APP/16/00517

PLAN-014040

Proposal: Erection of single storey garage to the East elevation.
Site: 11A Stirling Avenue, Waterlooville, PO7 7NH.
APP/16/00517

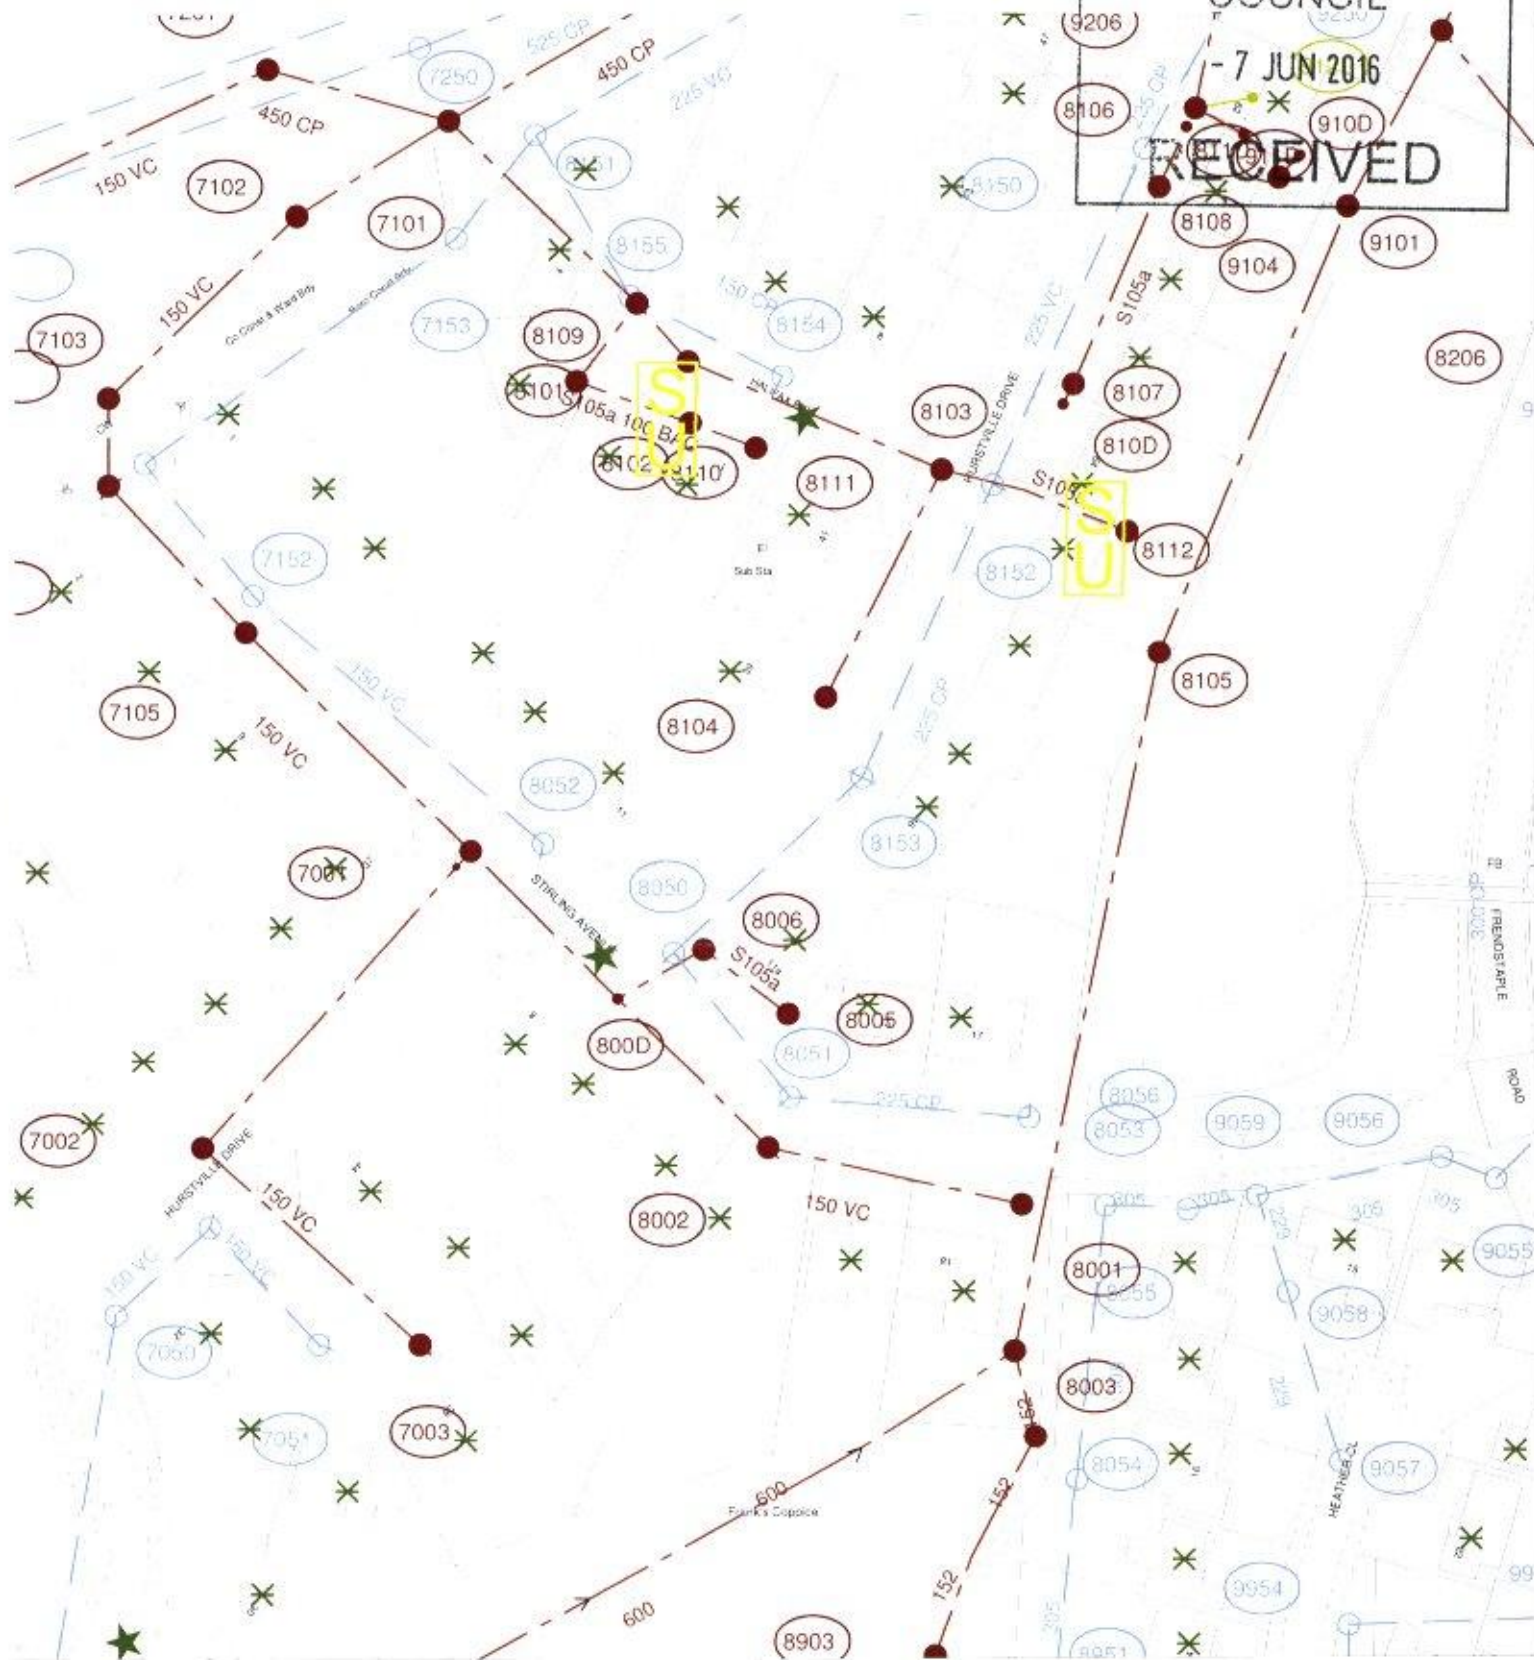
Please find attached a plan of the sewer records showing the approximate position of a public foul sewer crossing the site

It appears that the developer is intending to build close to a public foul sewer which is crossing the site. Building over to a "public sewer" is not normally permitted by Southern Water.

However, under certain circumstances building over a minor sewer may be allowed. The conditions associated with the build over/close to a sewer are contained in Southern Water guidance notes which are available at: www.southernwater.co.uk. A formal application to build close to the sewer will required to be submitted by the applicant.

In order to protect drainage apparatus, Southern Water requests that if consent is granted, a condition is attached to the planning permission. For example: "The developer must agree with Southern Water, prior to commencement of the development, the measures to be undertaken to protect the public sewer."
